# Access Compliance Report

## Public Rights-of-Way

### (Curb Ramps)

Intersection ID: 10016753	Main Street: PUMPERNICKEL_RD	Cross Street: N/A	Location: SW
ADA ID: 56DA2EE9D024	Ramp Type: Perp	Initial Pass/Fail: Fail	Overall Compliance: No
		Severity Score: 12.5

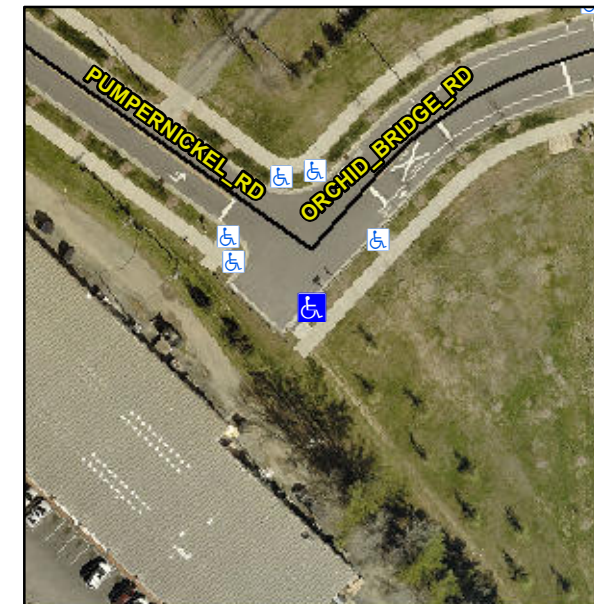
**R304.2.2**

Compliance	Description	Data	Compliance	Description	Data
N/A	Ramp Length (in)	96.0	No	Ramp Slope (%)	10.0
Yes	Ramp Width (in)	94.0	Yes	Ramp XSlope (%)	1.7
N/A	Flare Type LT	N/A	N/A	Flare Type RT	N/A
N/A	Flare Slope LT (%)	N/A	N/A	Flare Slope RT (%)	N/A
N/A	Flare Traversable LT?	N/A	N/A	Flare Traversable RT?	N/A
N/A	Landing Length (in)	N/A	N/A	DWS Provided?	N/A
N/A	Landing Width (in)	N/A	N/A	DWS Contrast?	N/A
N/A	Landing Slope (%)	N/A	N/A	DWS Length (in)	N/A
N/A	Landing X Slope (%)	N/A	N/A	DWS Full Width?	N/A
N/A	Landing Curb? (Y/N)	N/A	N/A	DWS Offset (in)	N/A
N/A	Shared Landing?	N/A			
N/A	Gutter Ponding?	N/A	N/A	Gutter Slope (%)	N/A
N/A	Gutter Lip Ht (in)	N/A	N/A	Gutter X Slope (%)	N/A
N/A	Painted X Walk1?	No	N/A	Painted X Walk2?	N/A
	X Walk 1 Direction	To NW		X Walk 2 Direction	N/A
N/A	X Walk 1 Width (in)	N/A	N/A	X Walk 2 Width (in)	N/A
	X Walk 1 Slope (%)	0.3		X Walk 2 Slope (%)	N/A
	X Walk 1 X Slope (%)	0.6		X Walk 2 X Slope (%)	N/A

**Remove & Replace Entire Ramp.**
